The Columbia Historic Zoning Commission will meet on Wednesday, November 19, 2025 at 4:00 PM in Council Chambers on the basement level of City Hall, 700 N. Garden Street, to consider the following:

**City of Columbia**  
HISTORICAL ZONING COMMISSION  
September 17, 2025

**PROJECT DESCRIPTION:** The Certificate of Appropriateness Request is for exterior door replacements

# 1122 S. HIGH STREET

**1 SOUTH ELEVATION**  
A-2.1 SCALE: 1/8"=1'-0"

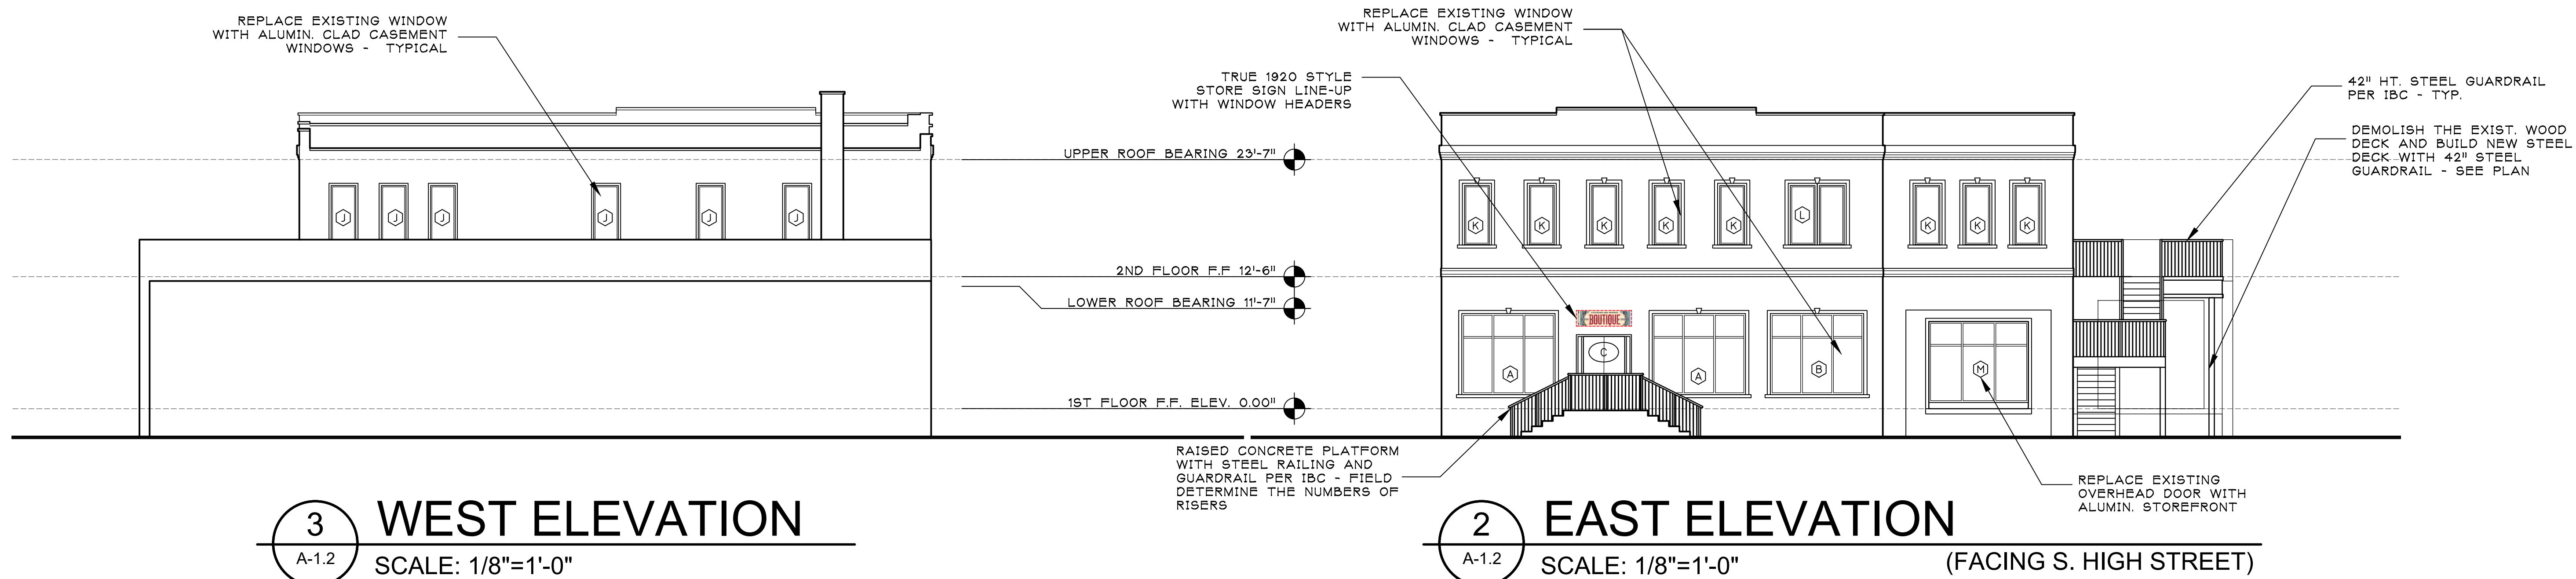
Staff is supportive of this proposal, except for the proposed removal of the single man door on the south elevation.

**§5.14 (b)** of the Historic Design Guidelines states, *“Door openings shall not be filled in, reduced, or enlarged.”* The intent here is that façade openings shall be maintained intact for historical reference and preservation. Although the staff does not support the removal request by the applicant, I would like to note that the south elevation is not the main frontage façade of this structure, and therefore, a secondary elevation façade that has secondary street frontage and is not the main entry/focal point of façade alignment.

**Staff does not make a recommendation and would instead defer to the Historic Commission for a ruling.**

Discussion of Vent Screening Options

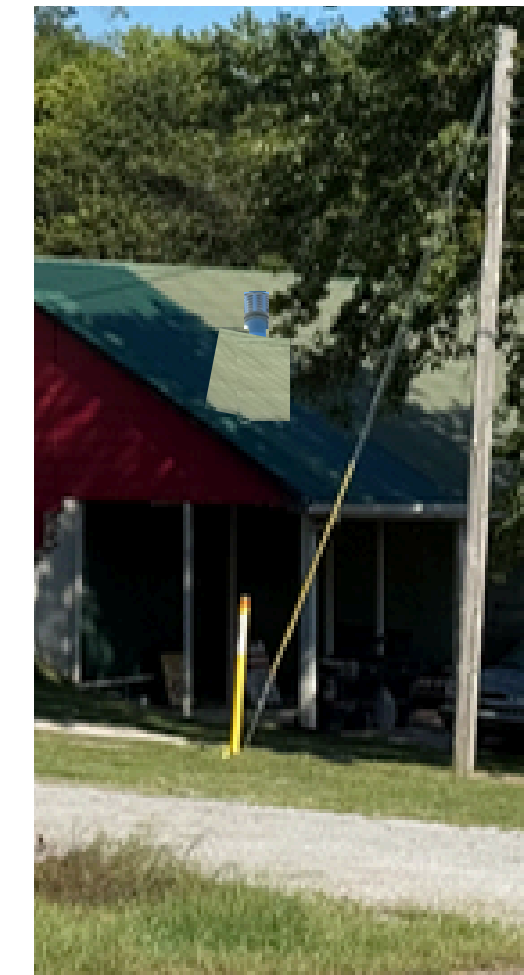
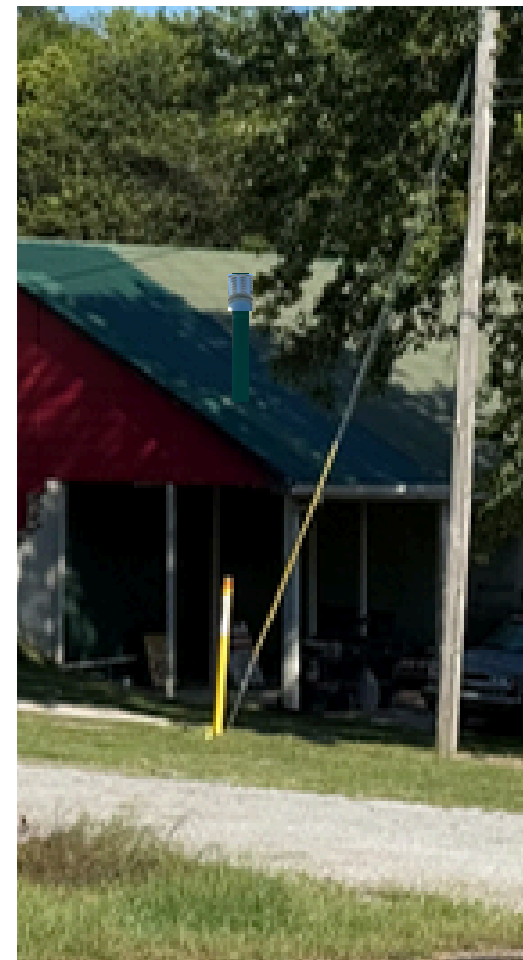
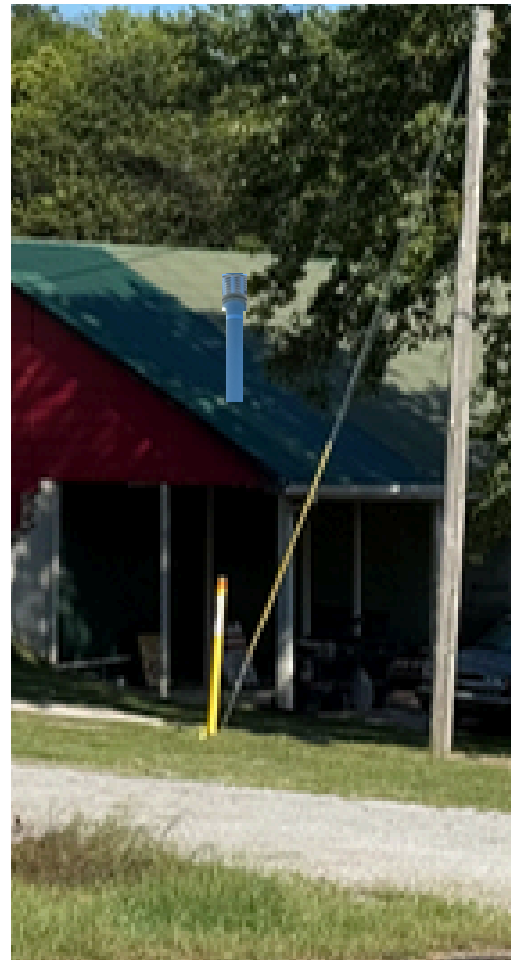
The applicant is proposing these changes to accommodate a newly proposed business, which would add benefit to the surrounding area and the ARTS District. As included in the packet, the changes the applicant is submitting, if approved, would result in the addition of three walls and an entrance door facing W 11<sup>th</sup> Street being constructed at the rear portion of the existing carport (previously altered). Also, the addition of operational equipment (exhausts) from the roof line is shown on both the east and west slopes of the metal roof. The applicant has also included three illustrations for screening of these exhausts for consideration.

*Staff suggests the Historic Commission require the applicant to install a similar door in the new wall that would mirror the existing façade door to provide a more visually aesthetic façade from the Frontage.*
